Access Compliance Report

Public Rights-of-Way

Intersection ID: 26202	Main Street: BALLANTRAE_VILLAGE_DR	Cross Street: SANDPIPER DR	Location: SW
ADA ID: D7930F5D06BB	Ramp Type: PerpDiag	Initial Pass/Fail: Fail	Overall Compliance: No
Codes/Mitigation Info/Possible Solution		Field Measurements/Component Compliance	
Severity Score: 21.25

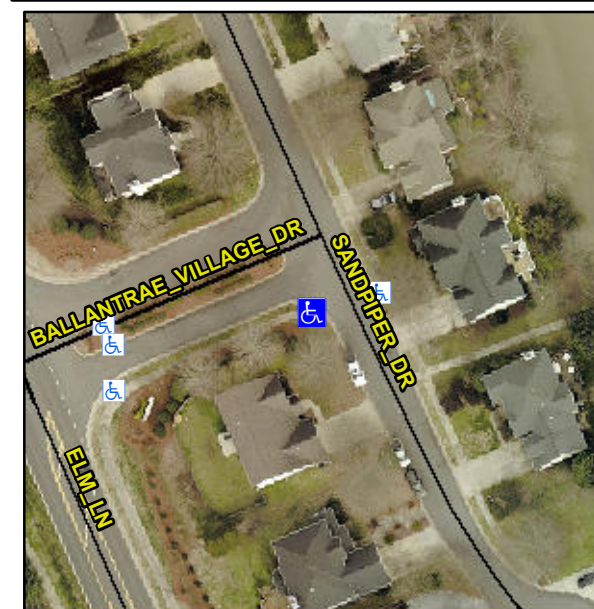
Not Found, R304.5.1, R304.5.3

Compliance	Description	Data	Compliance	Description	Data
N/A	Ramp Length (in)	97.0	Yes	Ramp Slope (%)	7.1
No	Ramp Width (in)	36.0	No	Ramp XSlope (%)	6.6
N/A	Flare Type LT	N/A	N/A	Flare Type RT	N/A
N/A	Flare Slope LT (%)	N/A	N/A	Flare Slope RT (%)	N/A
N/A	Flare Traversable LT?	N/A	N/A	Flare Traversable RT?	N/A
N/A	Landing Length (in)	N/A	N/A	DWS Provided?	N/A
N/A	Landing Width (in)	N/A	N/A	DWS Contrast?	N/A
N/A	Landing Slope (%)	N/A	N/A	DWS Length (in)	N/A
N/A	Landing X Slope (%)	N/A	N/A	DWS Full Width?	N/A
N/A	Landing Curb? (Y/N)	N/A	N/A	DWS Offset (in)	N/A
N/A	Shared Landing?	N/A			
N/A	Gutter Ponding?	N/A	N/A	Gutter Slope (%)	N/A
N/A	Gutter Lip Ht (in)	N/A	N/A	Gutter X Slope (%)	N/A
N/A	Painted X Walk1?	No	N/A	Painted X Walk2?	No
	X Walk 1 Direction	To E		X Walk 2 Direction	To N
N/A	X Walk 1 Width (in)	N/A	N/A	X Walk 2 Width (in)	N/A
	X Walk 1 Slope (%)	1.4		X Walk 2 Slope (%)	0.7
	X Walk 1 X Slope (%)	1.4		X Walk 2 X Slope (%)	2.3

Remove & Replace Curb Ramp With Two New Directional Ramps or Equivalent.
